TOWN OF JONESBOROUGH
Town Hall Board Room
123 Boone Street
Jonesborough, TN 37659

The Jonesborough Tree and Townscape Board will meet at 10:00 a.m., Tuesday, February 24th, 2026, in the Board Room at Town Hall, 123 Boone Street, Jonesborough, TN, to consider the following agenda:

SUBJECT: Trailblazer Coffee

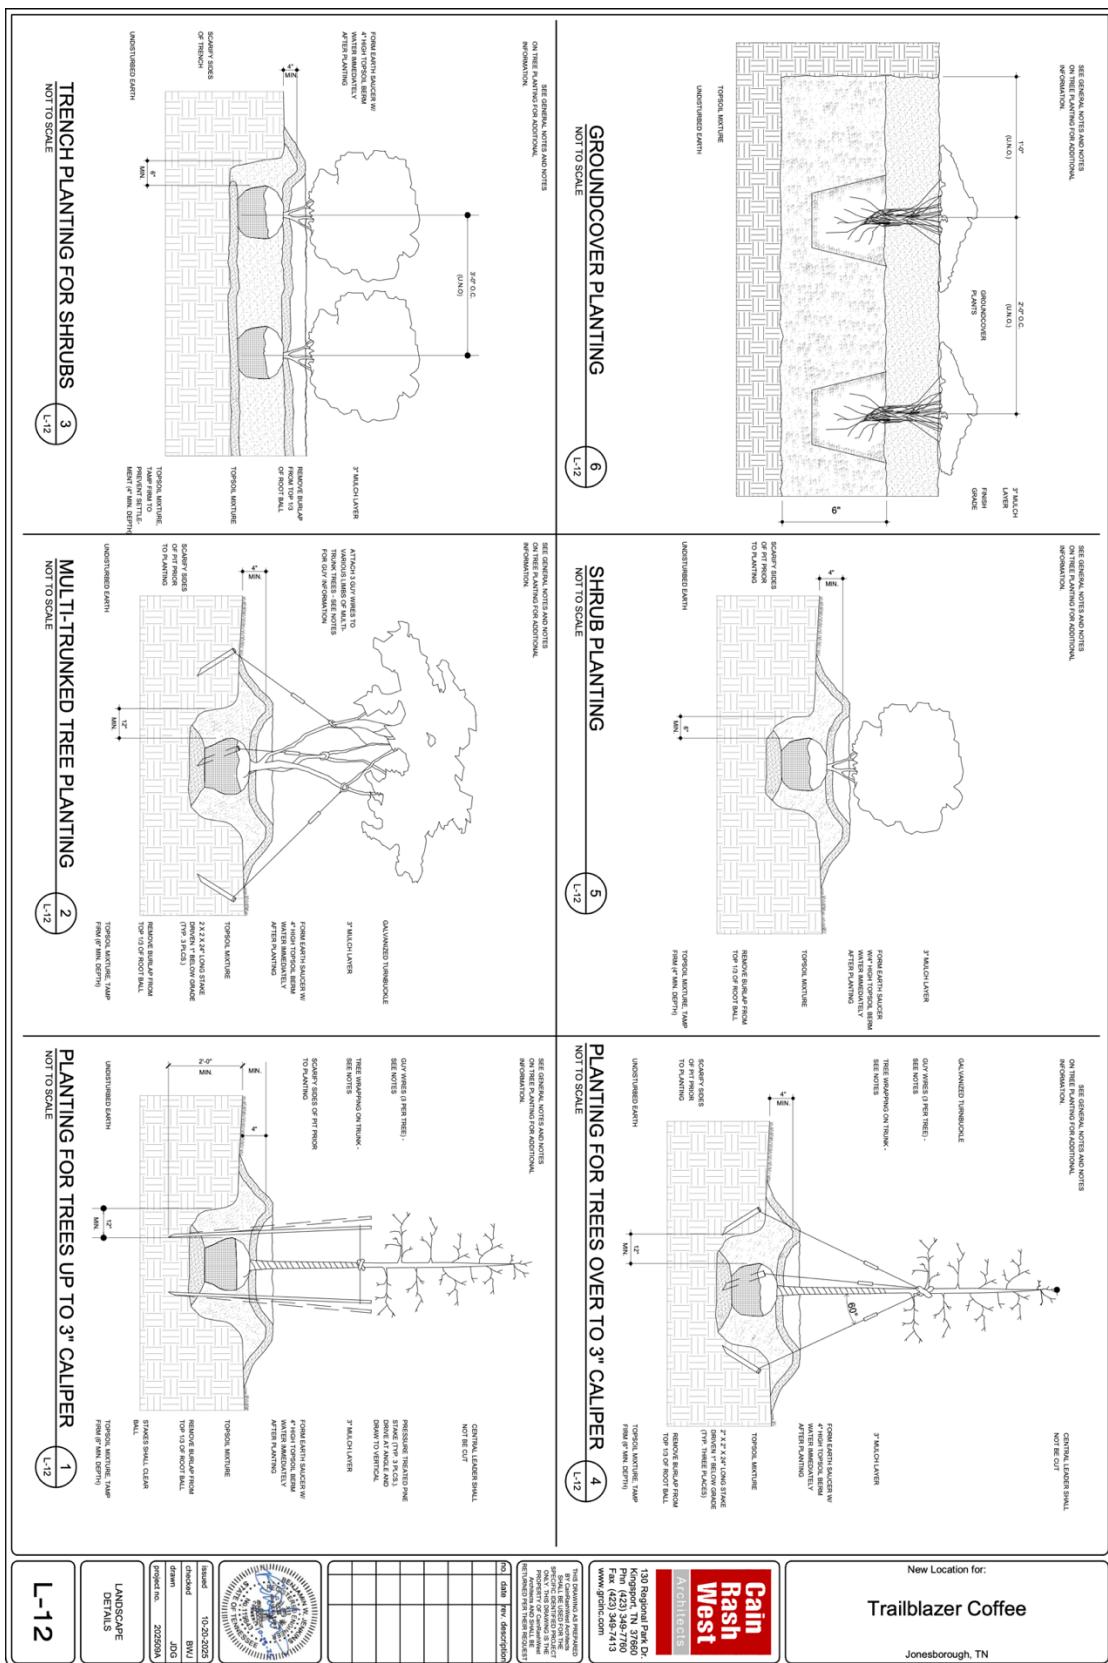
The east and west properties adjoining 304 East Jackson Blvd. are zoned B-3 Arterial Business. The south property is zoned B-4 Intermediate Business. Therefore, no buffer is required as stated in section 11-611, Buffering, of the Landscape Requirements.

The north side of the property facing East Jackson Blvd. will require road frontage landscaping. The linear footage measures 295'. Frontage requirements include one (1) tree for every 50'. $1 \text{ tree}/50' \times 295' = 5.9 \sim 6 \text{ trees.}$

Three (3) October Glory Maple and three (3) River Birch shade trees have been provided. This satisfies the road frontage requirements.

13 parking spaces including 1 ADA space have been provided. 1 tree is required per every 10 parking spaces with at least 2 shrubs per tree. 1 tree/10 spaces x 13 spaces = 1.3 ~ 1 tree with 2 shrubs.

Two (2) October Glory Maple and two (2) River Birch along with eleven (11) Yaupon Holly shrubs have been provided. This satisfies and exceeds the landscape requirements.

The Trailblazer Coffee Landscape Plan meets the minimum standards as per the Town's landscape requirements.

Approve the landscape plan as submitted.
